# Cable Assembly TP1-TP4 Insertion Loss (Comment #233)

## Comment #233

Cable assembly TP1-TP4 insertion loss specifications are proving challenging to meet when accounting for all sources of variation, specifically for the CA-A and CA-B cable assembly classes. A more manufacturable specification needs an additional 1 dB insertion loss to be allocated to the cable assembly for CA-A and CA-B.

**Figure 179A-1—Host-Nominal to Host-Nominal, Cable assembly, and test fixture insertion loss at 53.125 GHz**

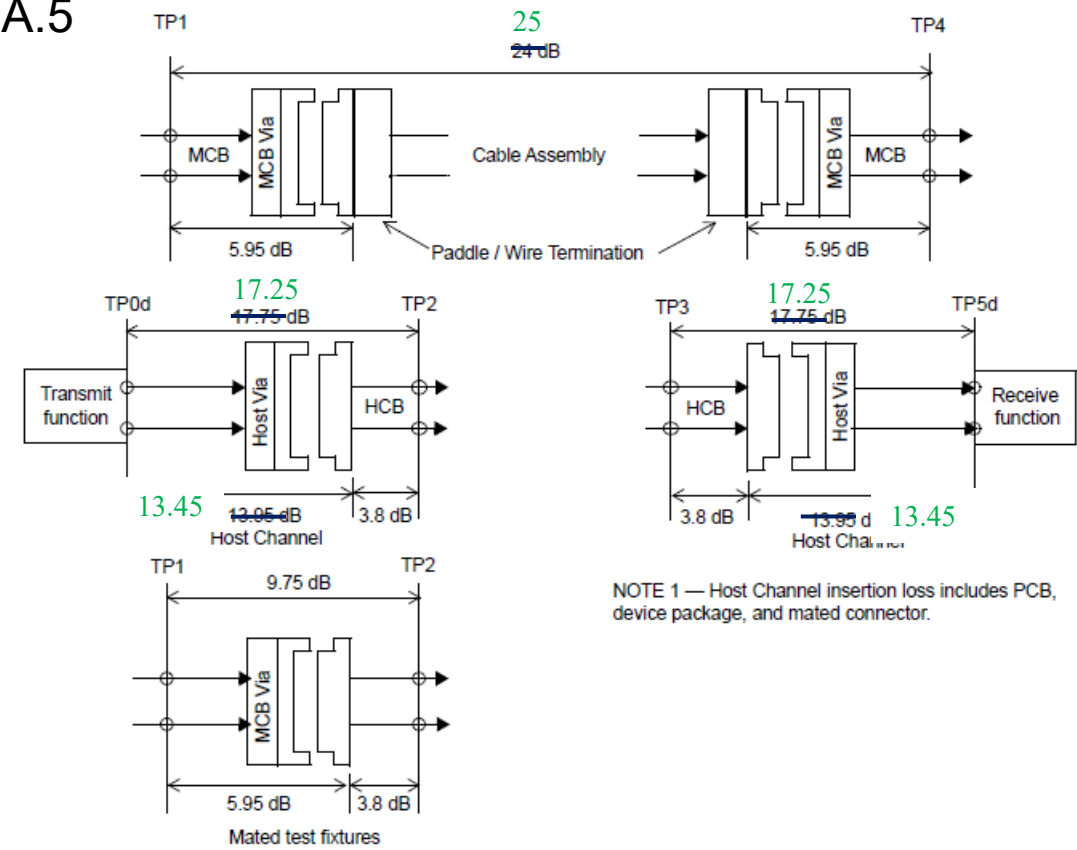
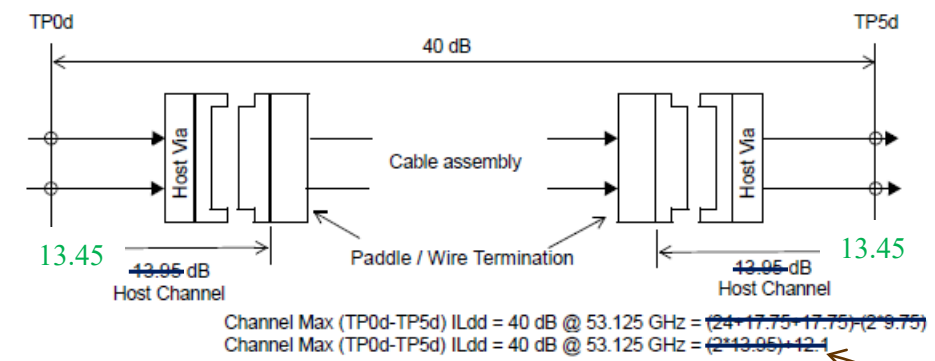
# Proposed Changes

NOTE 2 — The MCB and HCB ILdd allocations include the RF connector (up to the RF connector reference plane).

Channel Max (TP0d-TP5d) ILdd = 40 dB @ 53.125 GHz = (25+17.25+17.25)-(2\*9.75)  
Channel Max (TP0d-TP5d) ILdd = 40 dB @ 53.125 GHz = (2\*13.45)+13.1
